Service Bulletin

PRELIMINARY INFORMATION

Subject: Headliner Assembly Loose/Sagging at Rear of Sunroof Opening

Models: 2011-2012 Buick Regal
Equipped with Sunroof (RPO CF5)

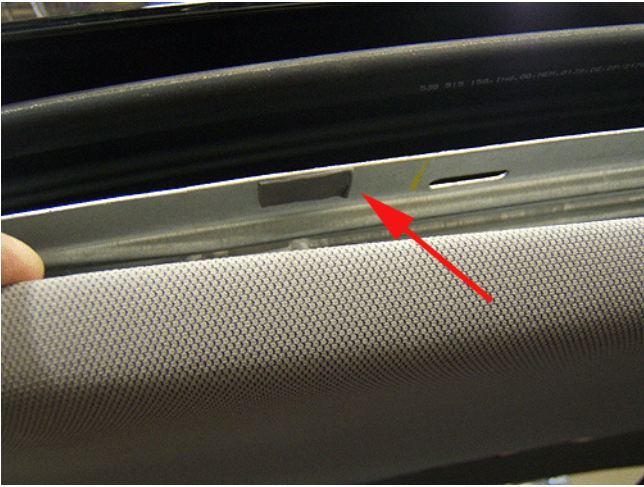
Some customers may comment that the headliner assembly is loose and/or sagging at the rear edge of the sunroof opening.

This condition may be caused by the hook and loop fastener adhesive failing, allowing the headliner to become separated from the sunroof housing.

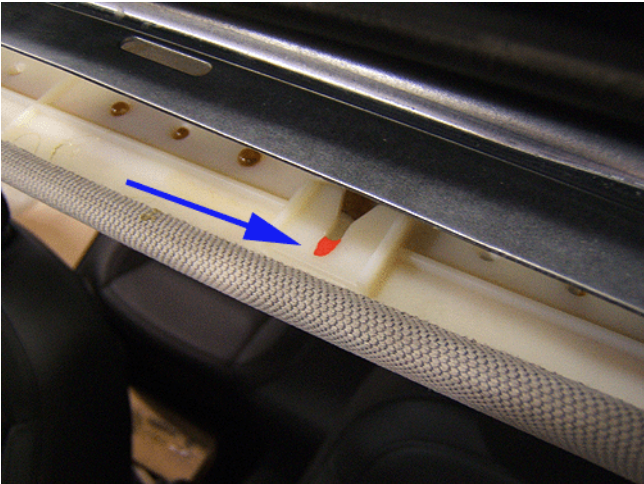
1. Remove the three hook and loop fasteners from the headliner assembly at the rear of the sunroof opening. Slide the fasteners out of the attachment slots in the headliner assembly.

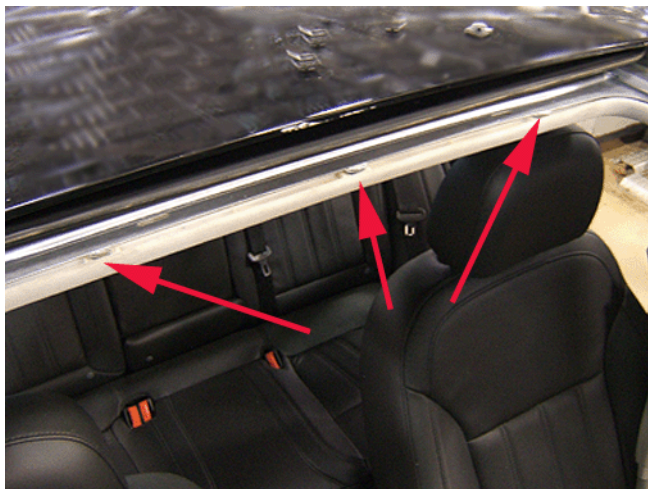
4. Using a paint pen or permanent marker, mark a 5 mm (3/16 in) area at the front edge of the three clip attachment slots as shown.

5. Use a small file or rotary bit on a die grinder to lengthen the attachment slots as shown. Use care to prevent over cutting the material.

6. Install the three new service magnets in the attachment slots. Position the magnets in a fore/aft location to ensure the magnets sit flat on the sunroof housing flange.
